Docket: NRC-2010-0143

Notice of Opportunity to Request a Hearing for the License Application from International Isotopes Fluorine Products, Inc.

Notice of Availability of Draft Environmental Impact Statement for the Proposed International Isotopes Fluorine Extraction Process and Depleted Uranium Deconversion Plant in Lea County, NM

Seismic Hazard Map

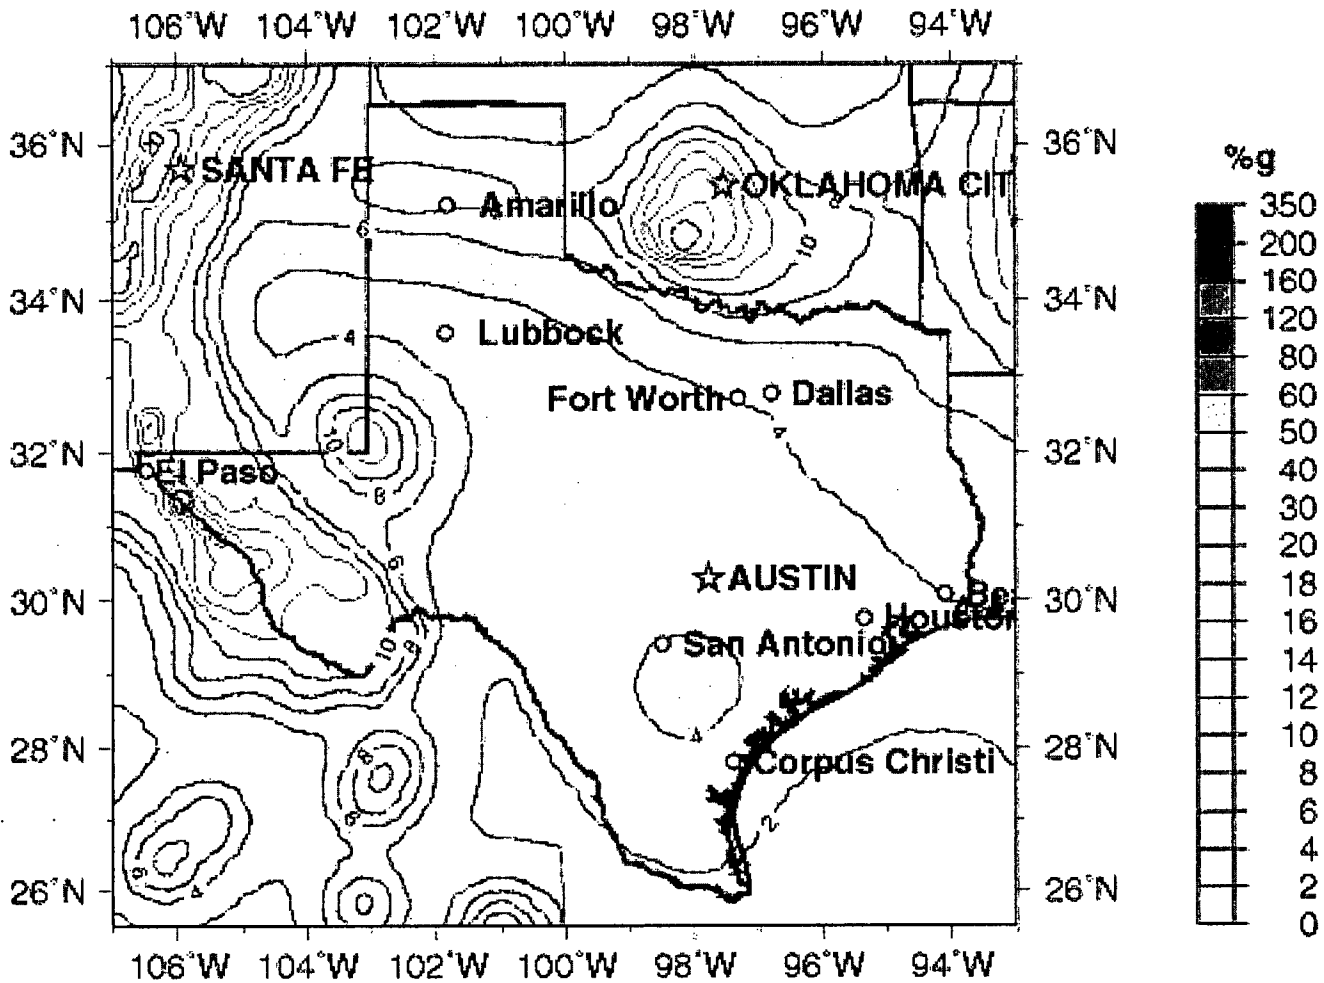
usgs says lea county is in earthquake hazard area/here is a copy of file the geology should be looked at again
<http://earthquake.usgs.gov/earthquakes/states/texas/hazards.php>

I think anything nuclear located over an earthquake zone is unsafe
